SUBJECT: REFERENCE TO TEMPORARY WAIVERS OF COMPLIANCE IN GUIDANCE DOCUMENTS ON OPERABILITY AND DEGRADED OR NONCONFORMING CONDITIONS

OGC'S COMMENTS ON GUIDANCE ON OPERABILITY AND DEGRADED/NONCONFORMING CONDITIONS

The following OGC comments must be addressed before OGC could indicate that it had no legal objection to the CRGR package discussing operability and degraded/nonconforming conditions provided to OGC on May 6, 1991.

4.8 Reasonable Assurance of Safety

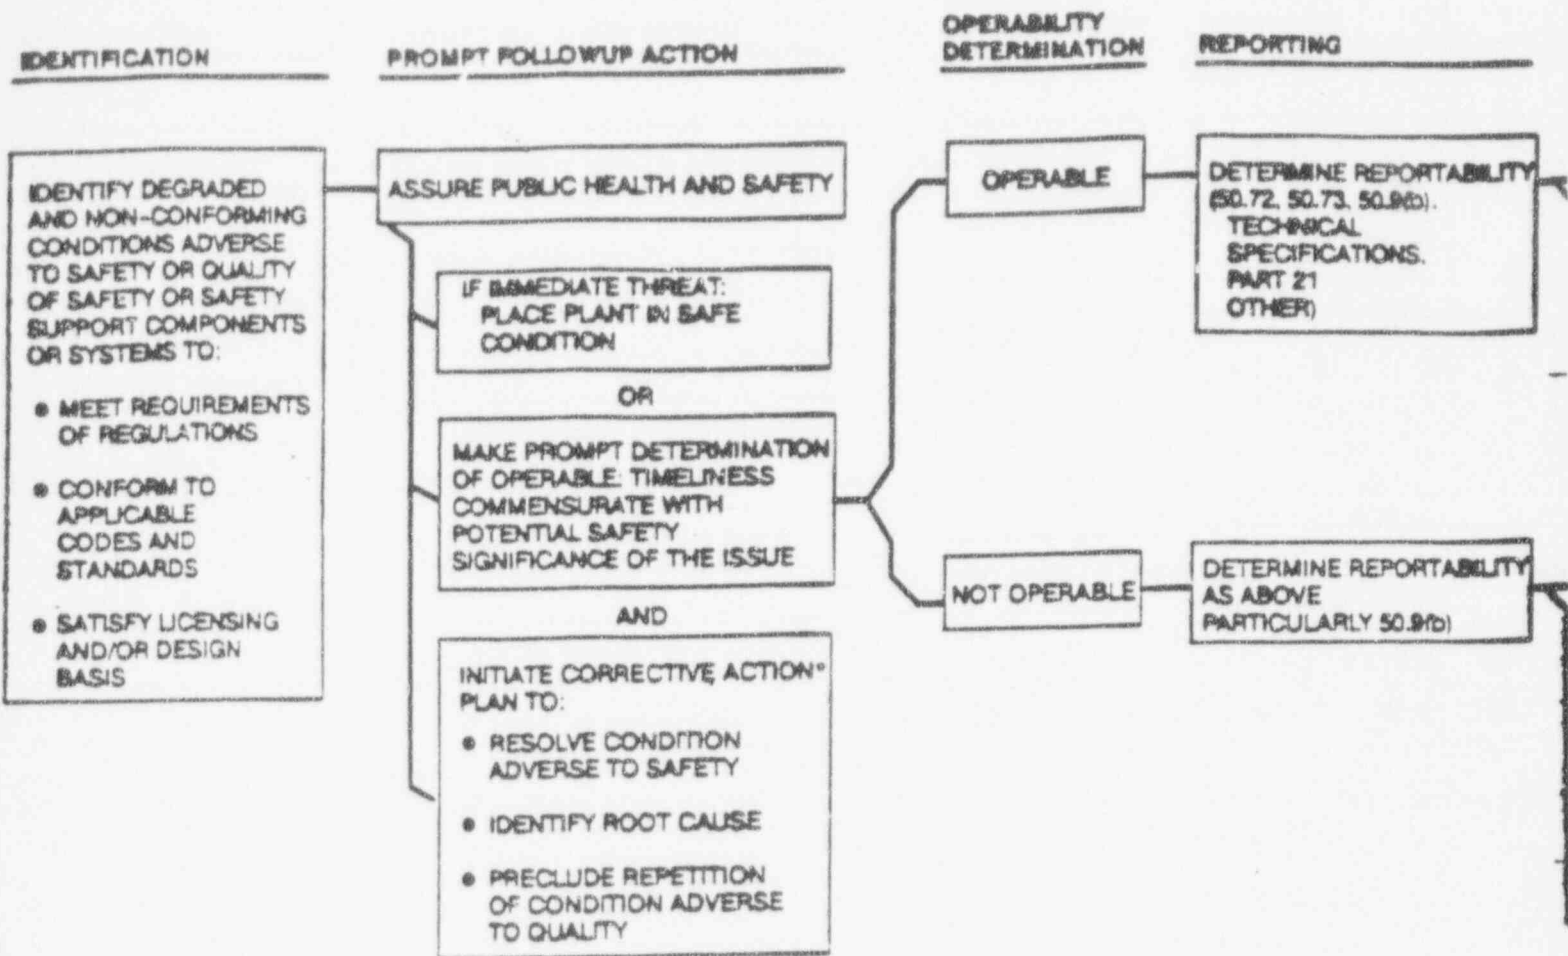
this has no further guidance, please
